# MITIGATION PLAN

## LONE HICKORY MITIGATION SITE

Re: NCIRT Review and USACE Approval of the Lone Hickory Mitigation Site Draft Mitigation Plan;  
SAW-2017-00100; DMS Project #97135

RE: Lone Hickory Mitigation Site  
Yadkin County, NC  
USACE AID#: SAW-2017-00100, NCDMS #: 97135  
FINAL Mitigation Plan – IRT Comment Response

Figure 11.1 Monitoring Plan - West Side  
Lone Hickory Mitigation Site  
Yadkin River Basin (03040101)

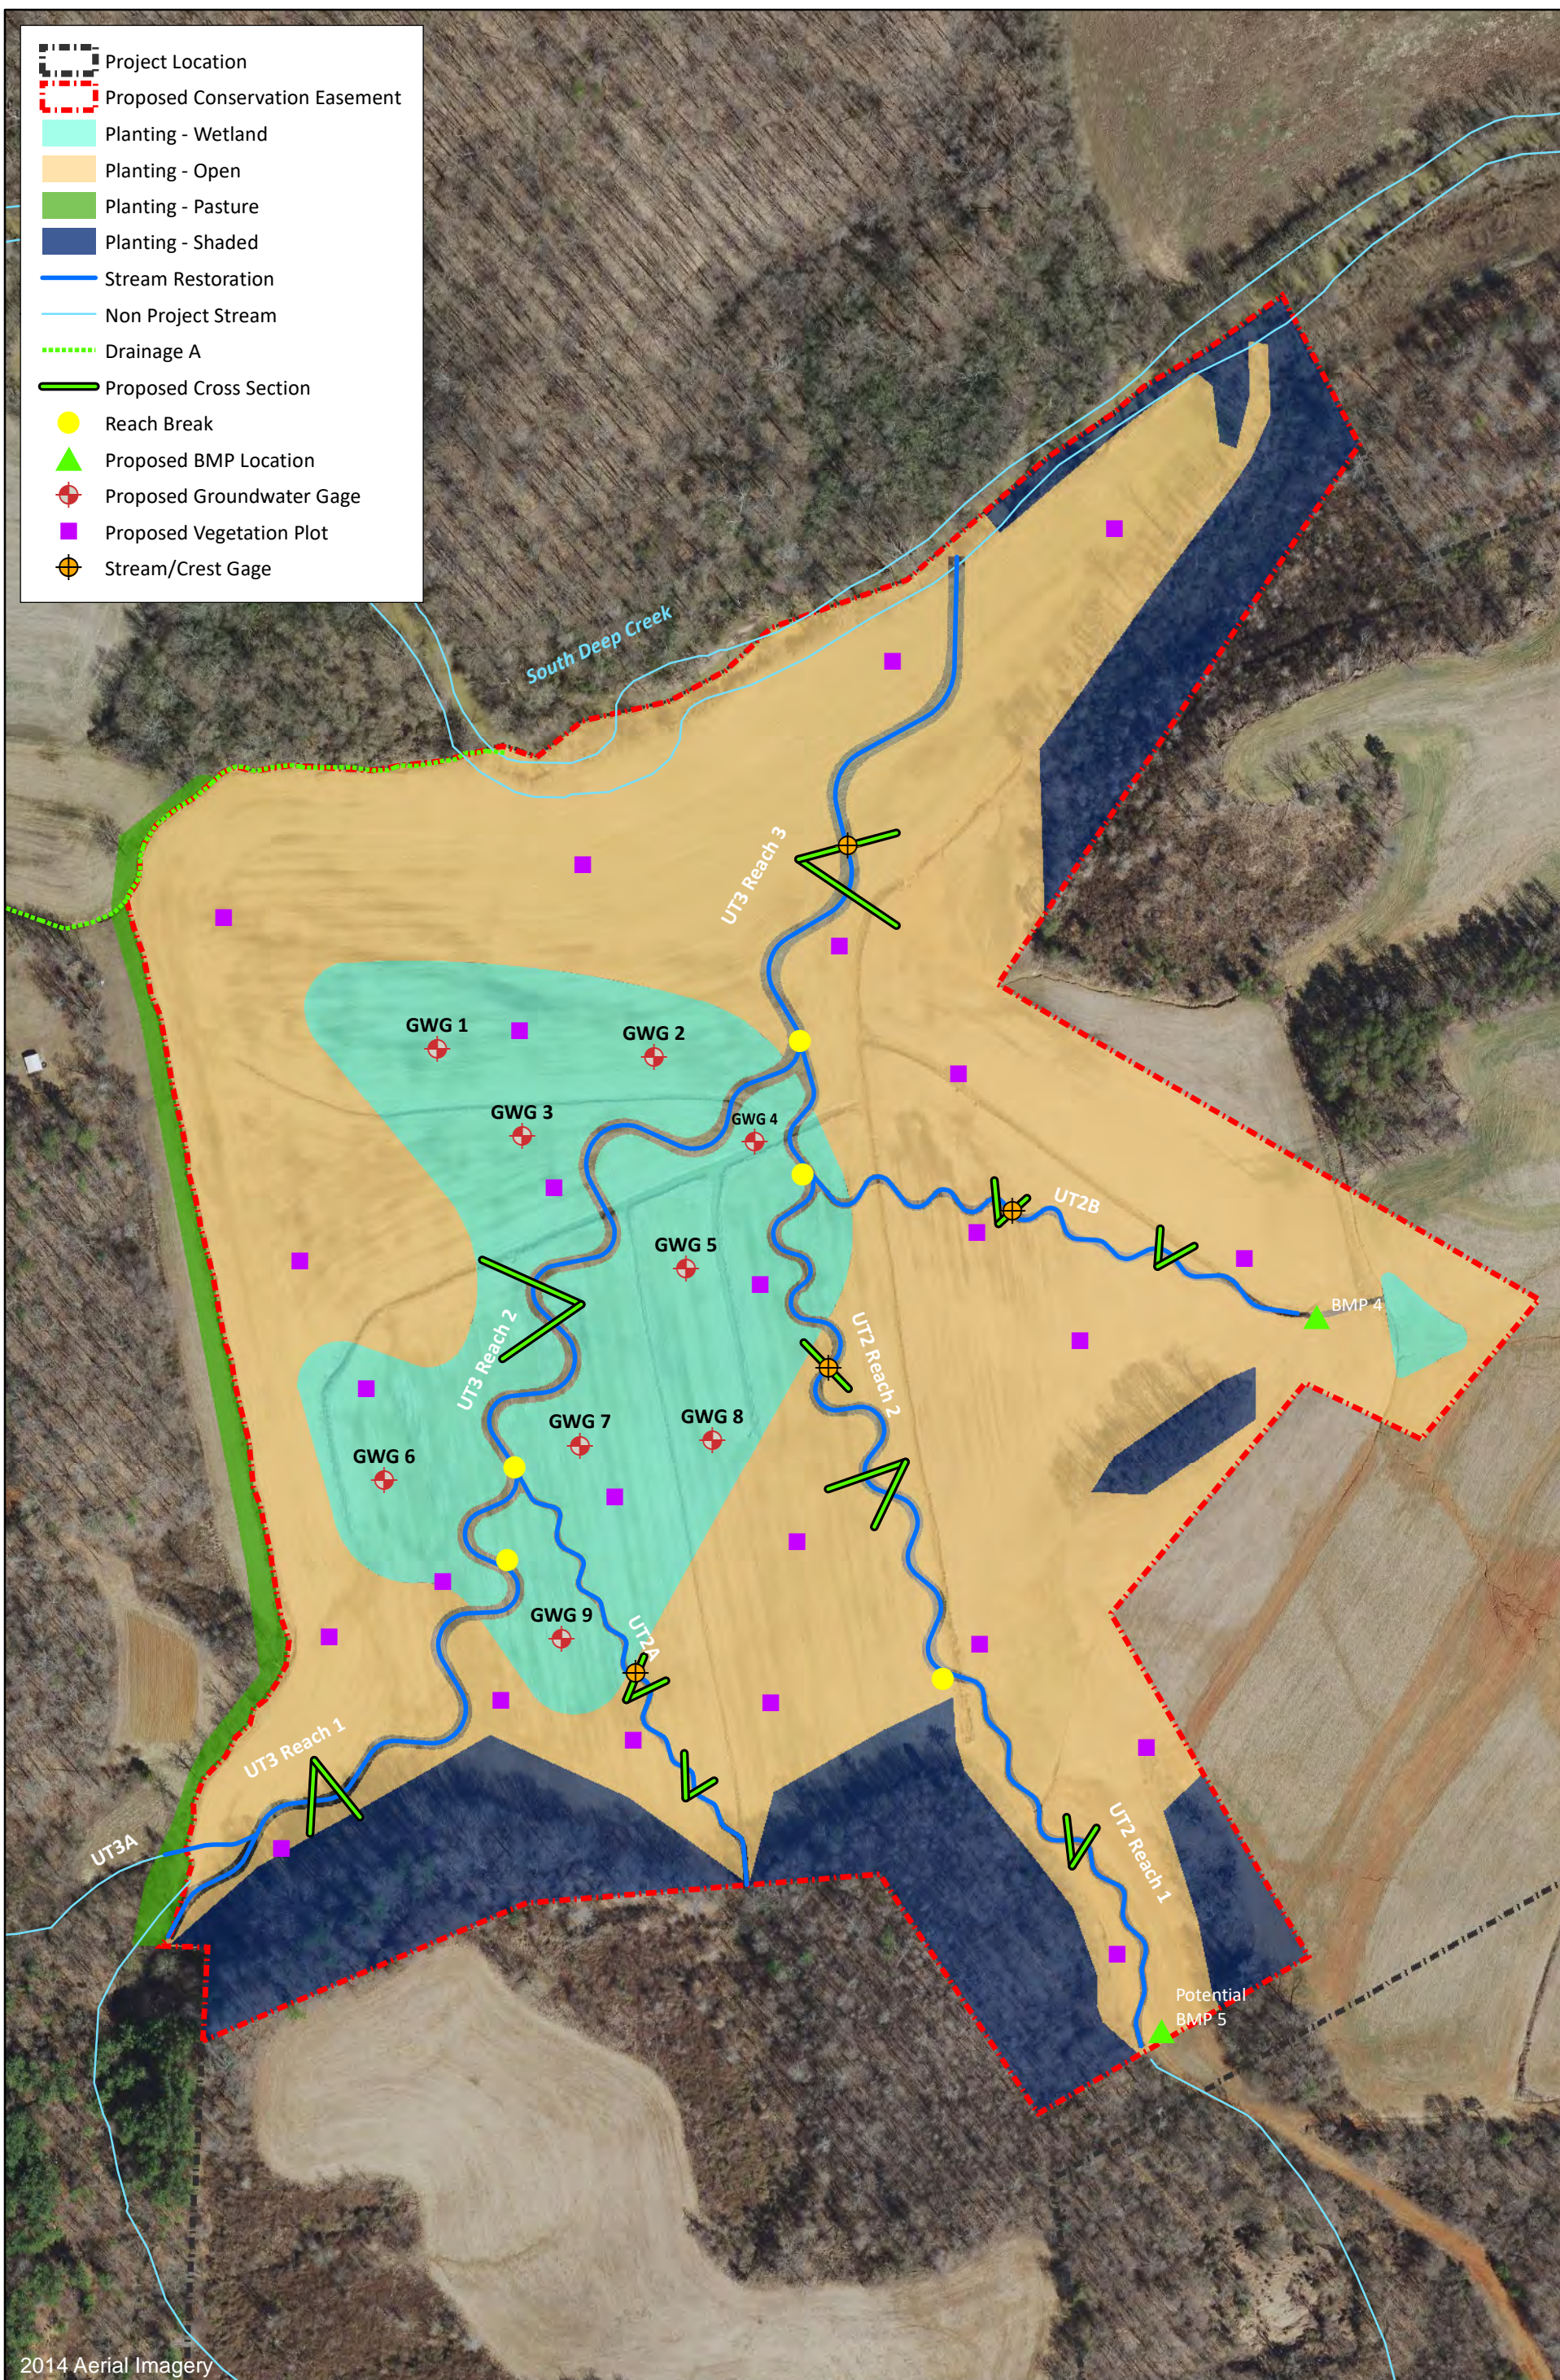
2. DWR notes that on Figure 11.1 that there are stream gauges planned to be installed on tribs UT2A and UT2B. DWR would like those gauges installed no further down than mid reach. DWR recommends the placement of the gauge for UT2A just before the proposed wetland polygon on Figure 11.1.

2. *DWR notes that on Figure 11.1 that there are stream gauges planned to be installed on tribs UT2A and UT2B. DWR would like those gauges installed no further down than mid reach. DWR recommends the placement of the gauge for UT2A just before the proposed wetland polygon on Figure 11.1.*

- a. Wildlands will install the a stream gage at midreach on UT2A and UT2B. The Mitigation Plan text on page 42, Section 8.1.5 Hydrology has been modified to state that "low flow channels (UT1 Reach 1, UT2A, and UT2B) will each have a stream gage pressure transducer installed midreach to document 30 consecutive days of baseflow." Figure 11.1 has been revised to show the proposed stream gage and monitoring cross sections located upstream of the proposed wetland polygon on UT2A.

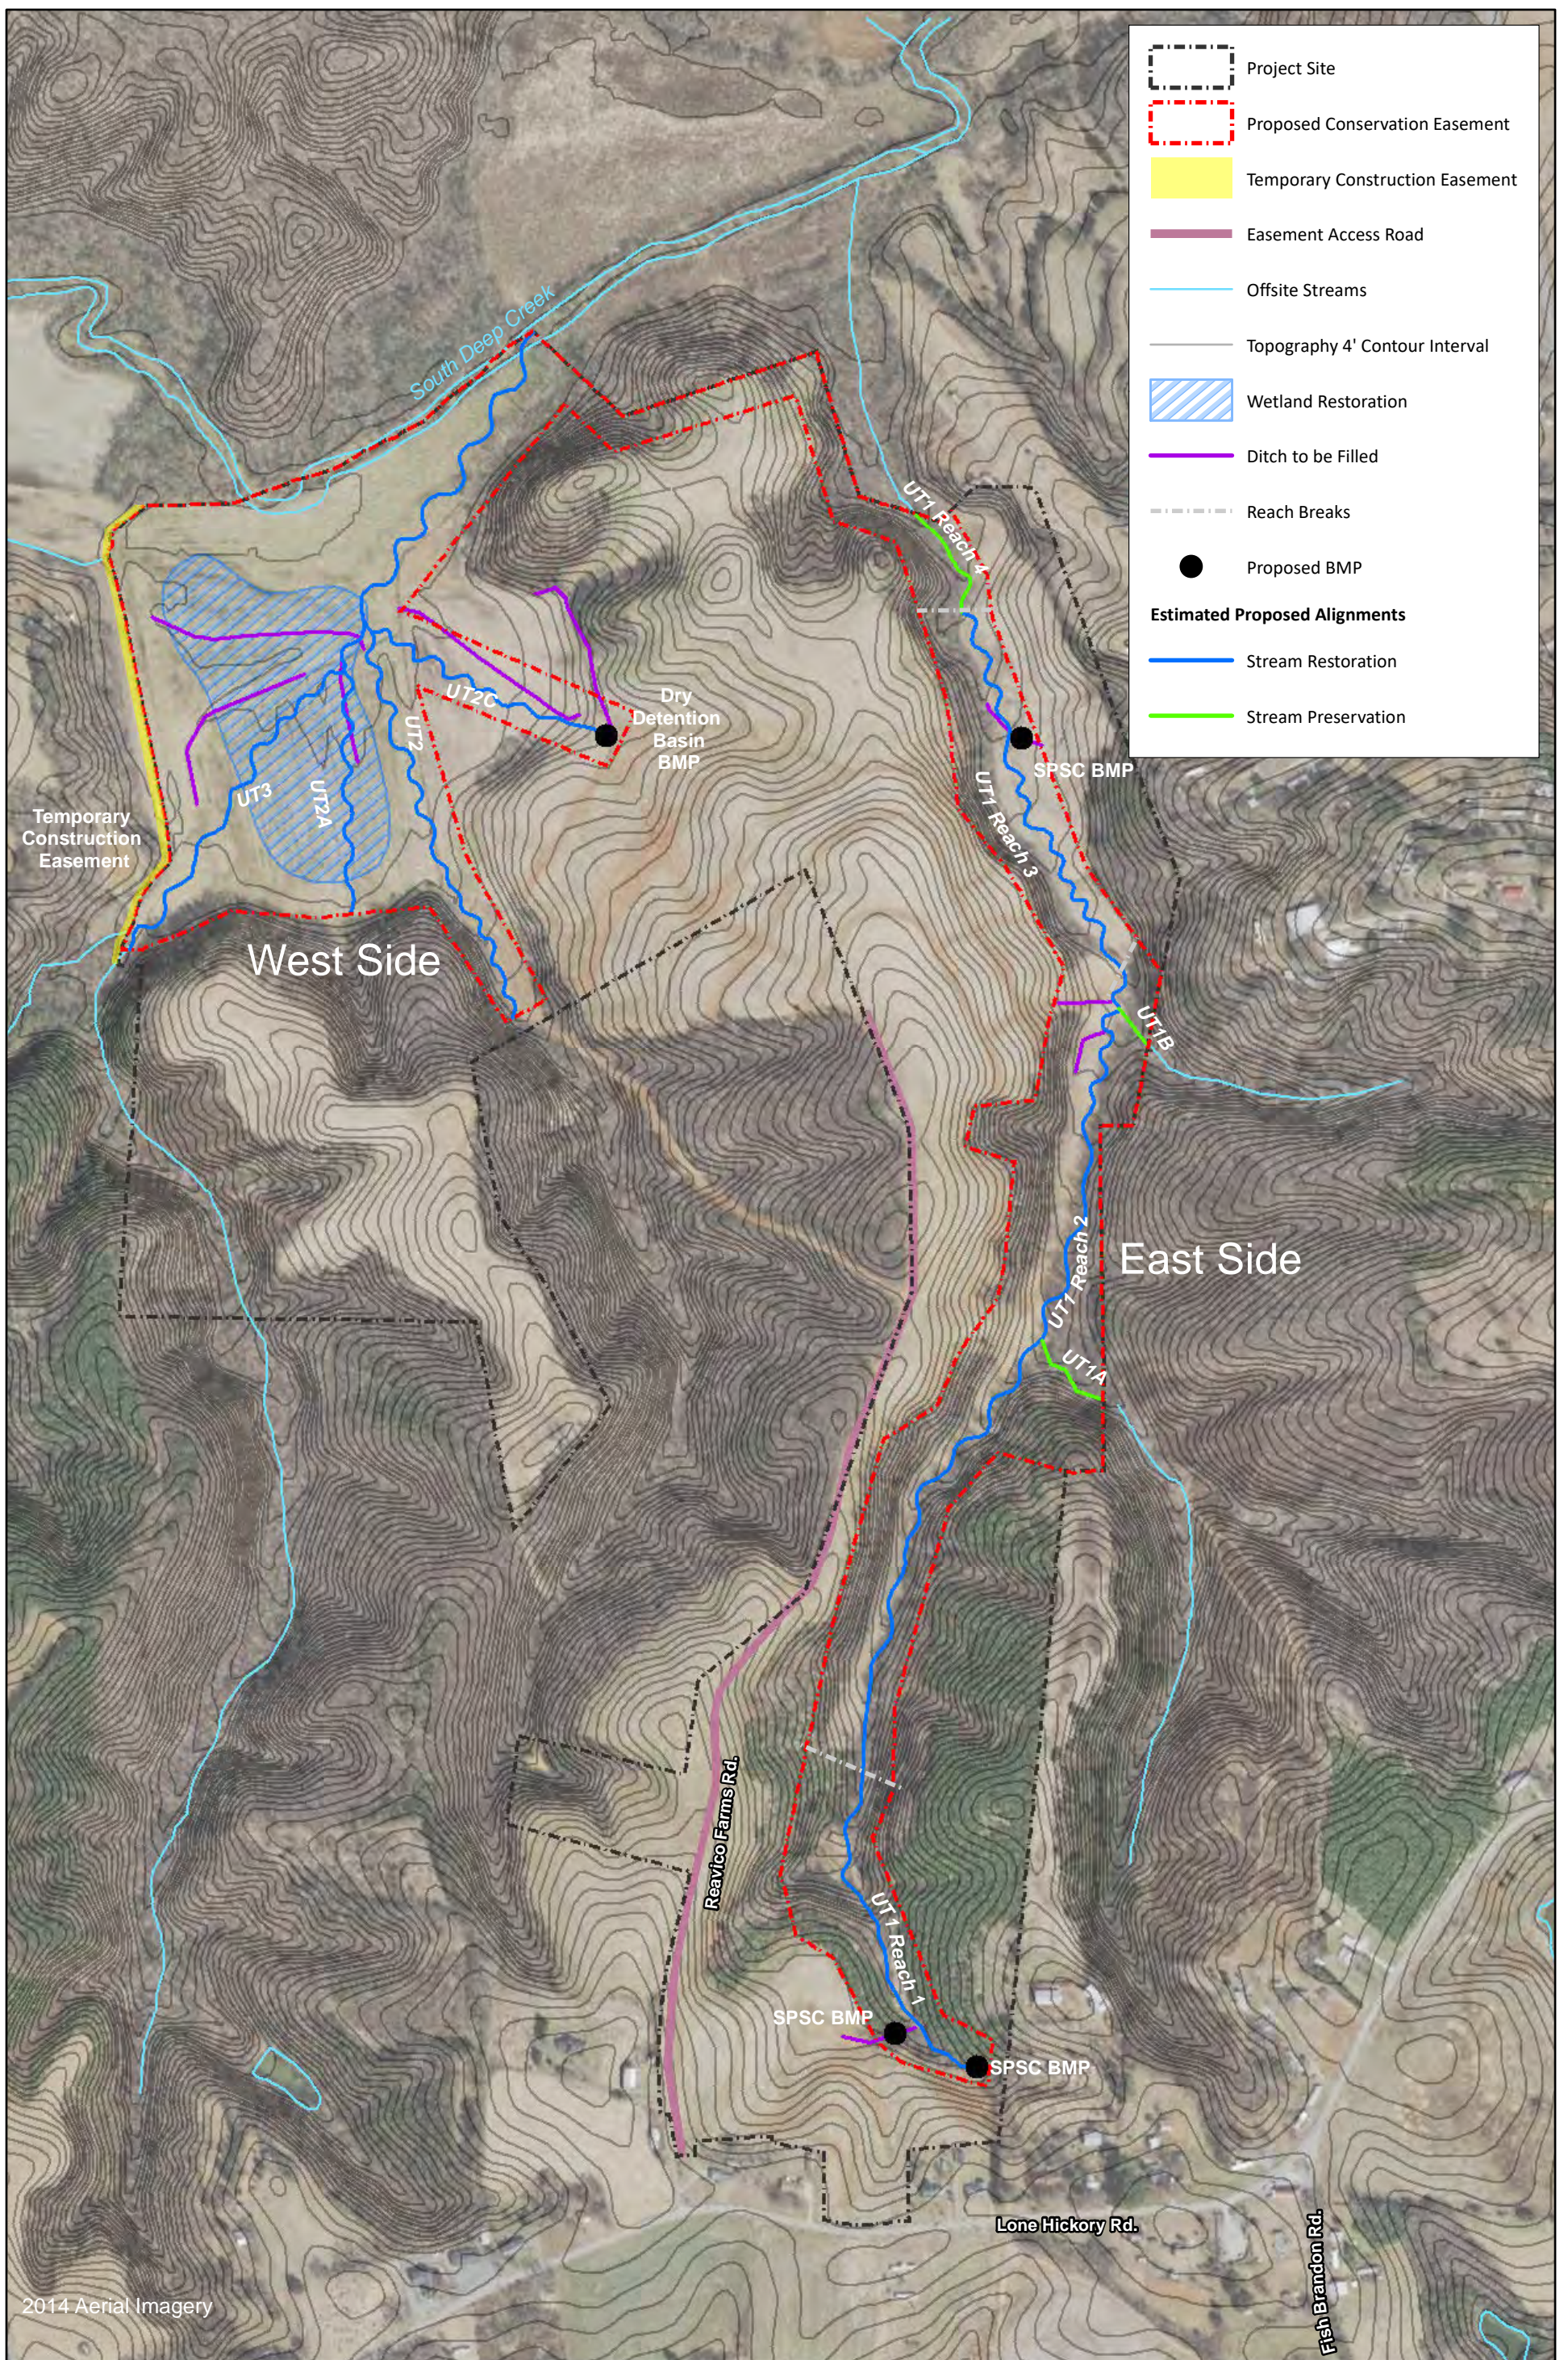
15. *Figure 2 Site Map and Figure 6 Concept Map show a channel labeled as UT2C. While Figure 8.1 Concept Map and Figure 11.1 Monitoring Plan shows the same channel labeled UT2B.*
  - a. Labels have been verified on the figures.
